# Aesthetic Assessment and Mitigation Recommendations for the Proposed VELCO Northwest Reliability Project (NRP) PROPOSED REROUTE ALTERNATIVES

**DOCKET 6860**  
**VELCO NW Reliability Project**

**Submitted to:**  
State of Vermont  
Department of Public Service  
Montpelier, VT

**Prepared by:**  
LandWorks  
Middlebury, VT

Mile 0.1  
Original  
Route

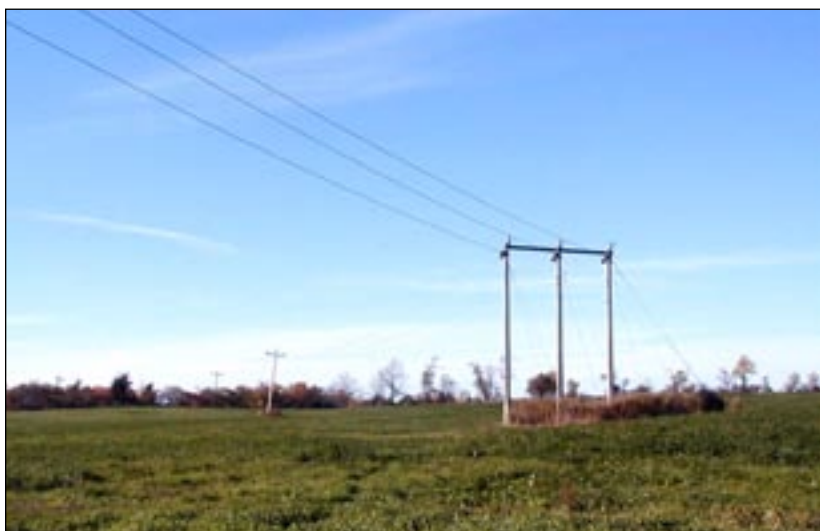
View looking south toward the substation. Line on the left hand side in photograph will remain in place. Line on the right will be replaced by 115kV line. Some degree of visual symmetry will occur with placement of additional H-Frame poles rather than additional single-poles, but the profile of two H-Frame side by side will increase the overall visibility of the structures in the landscape and against the horizon.

Mile 2.5  
Original  
Route

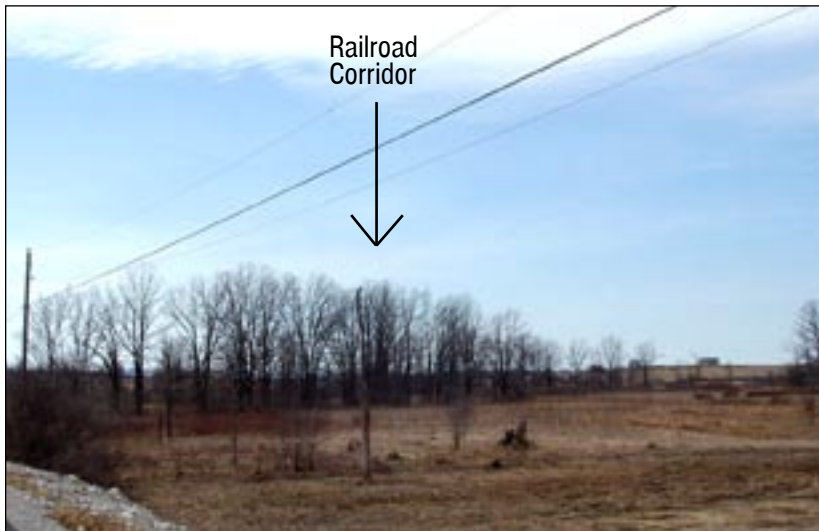
View from Lime Kiln Road, looking west at rail-crossing. Due to the existing treeline and the fact that this area is not highly scenic or densely settled, aesthetic impacts will not be highly adverse or undue.

Mile 1.4

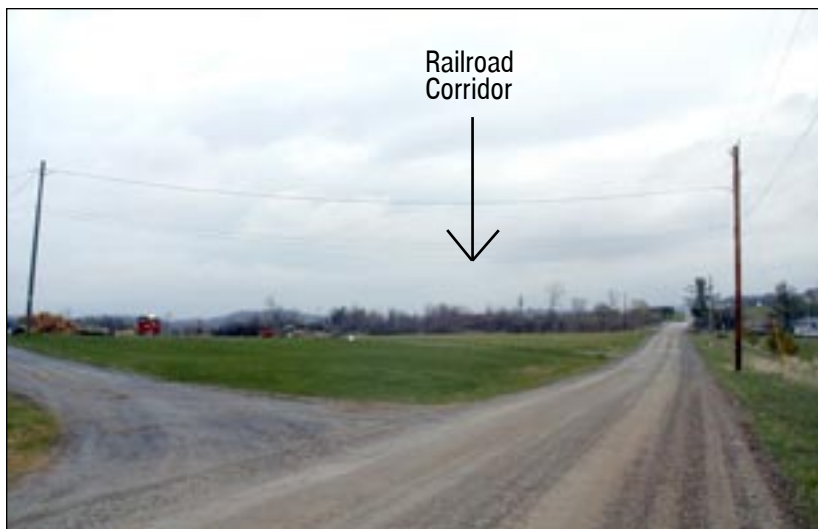
View north to railroad crossing on Middlebrook Road. Note the railroad corridor is currently screened by vegetation to the right of building. Clearing will be necessary. Some new screening to reduce impacts to the homes in the area should be considered.

Mile 1.4

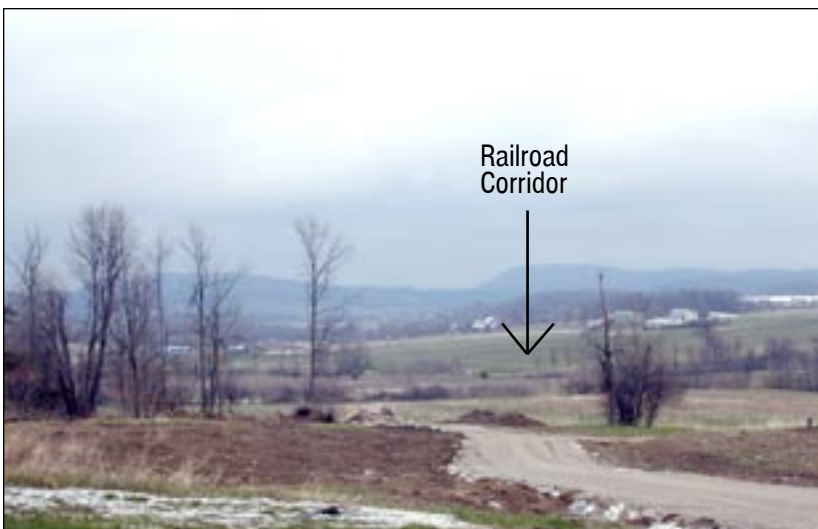
View of Middlebrook Road as it runs over the railroad crossing. This view is looking south. Careful pole placement will be desirable here to minimize visual impacts.

Mile 3.4

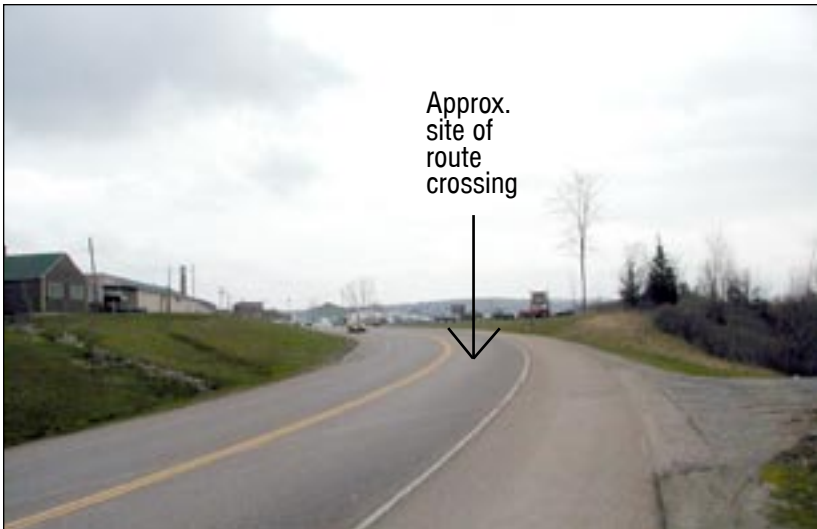
View of Kayhart crossing. The lines in the proposed reroute will cross Route 22A in advance of this rail bridge. Proposed substation to be located on land on the left side of this photograph. Recommended measures include screening, long spans, and very careful pole placement to keep poles to the periphery of the driver's view.

Mile 22.0  
Original  
Route

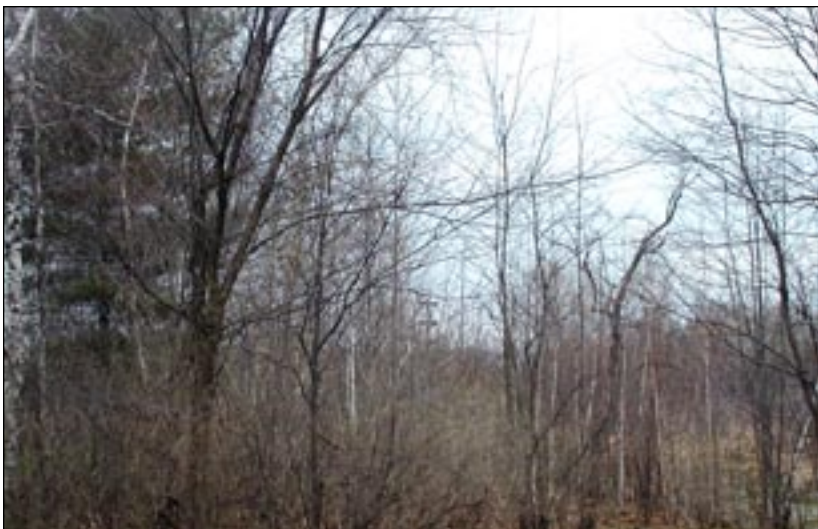
View of the existing line behind the Harbor View condominiums. The proposed line will run further away from this vantage point. The existing line will be removed.

### **LandWorks' Charlotte Alternative Route**

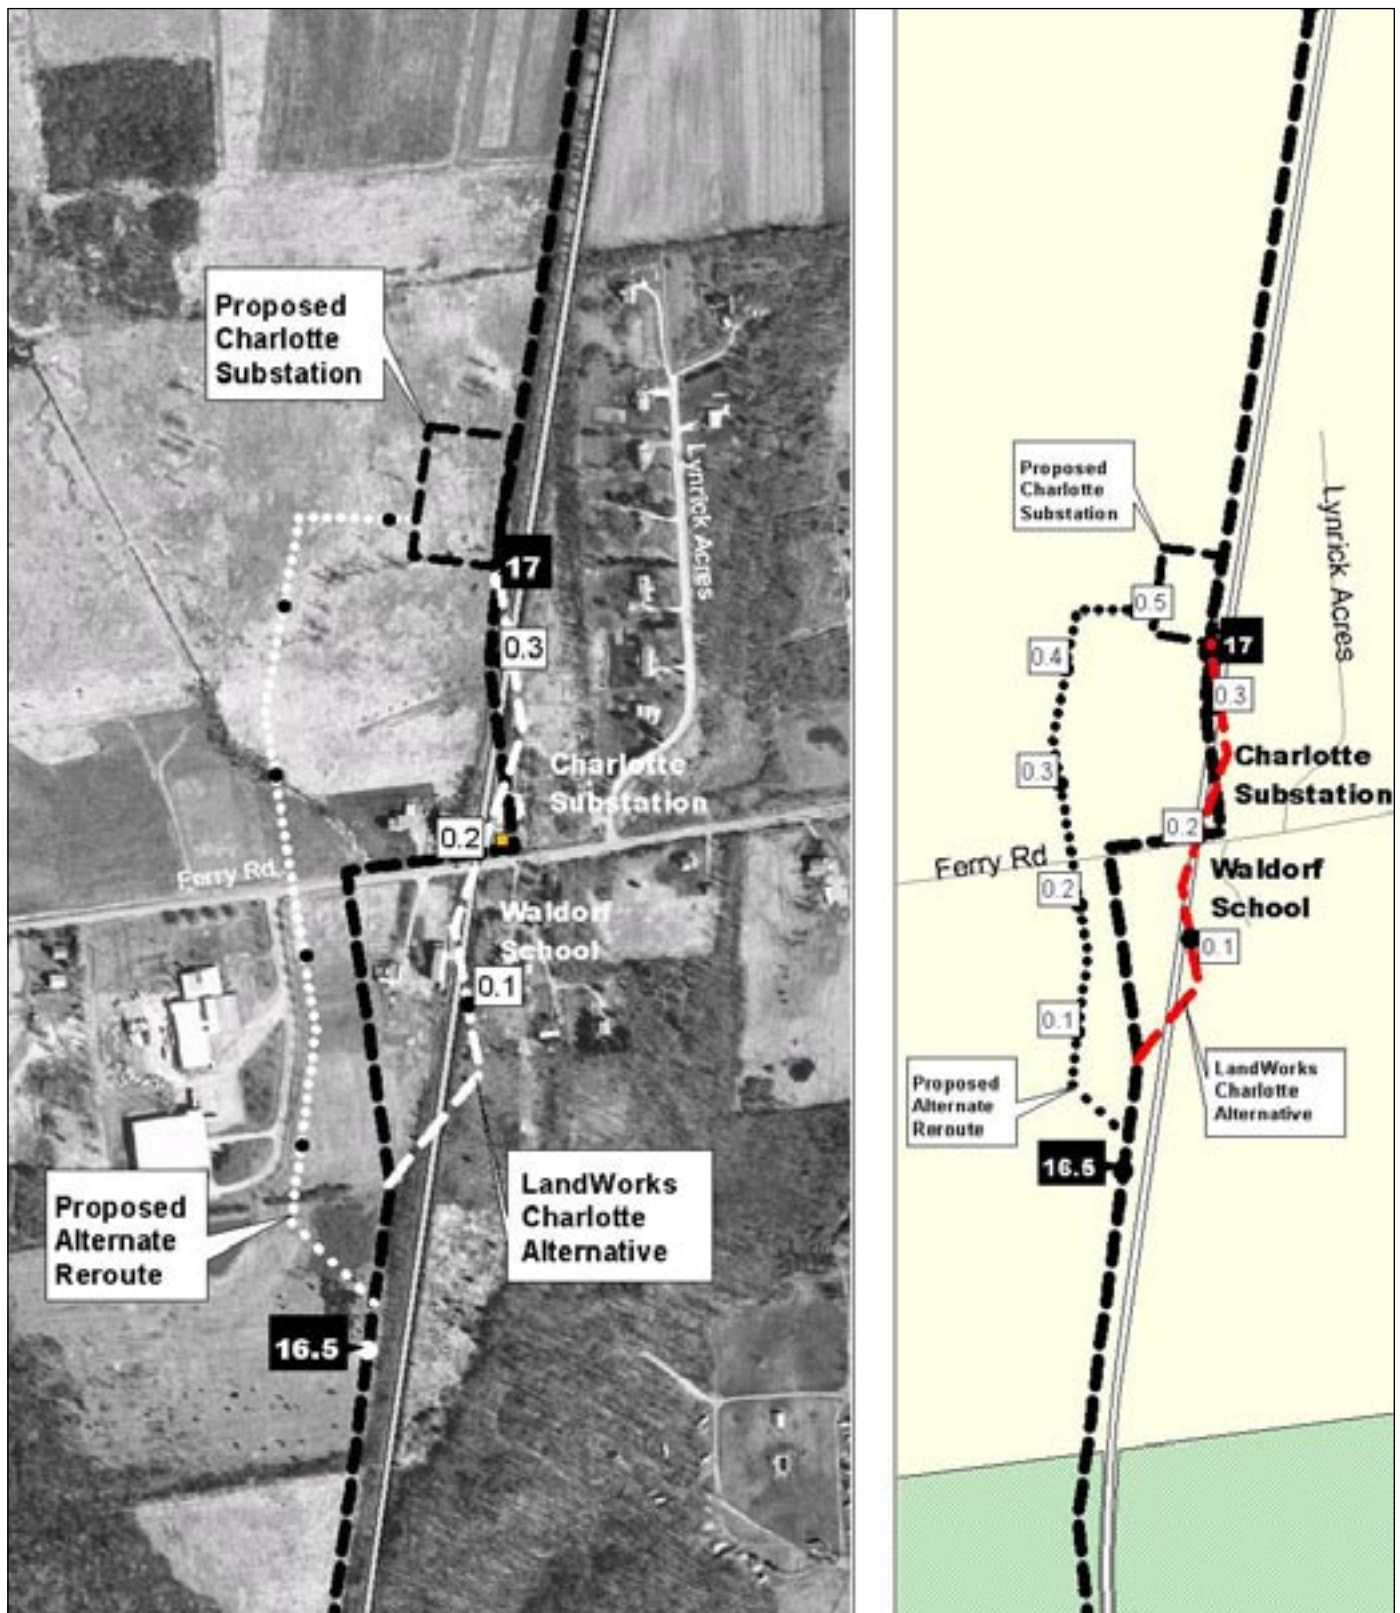
The following section provides analysis on the recommended Charlotte Alternative Reroute proposed by LandWorks. The map on the preceding page details the LandWorks' Charlotte Alternative Route. The LandWorks' Alternative Route crosses the tracks three times as it heads north in advance of the Ferry Road crossing. The design of this alternative route will require tall steel structures which will utilize the railroad corridor to the maximum extent and will minimize the impacts on the adjacent properties, namely the Waldorf School and the existing residences located along the east side of the railroad corridor. There will be one pole to the north of the existing Waldorf school building, between the parking lot and the railroad tracks.
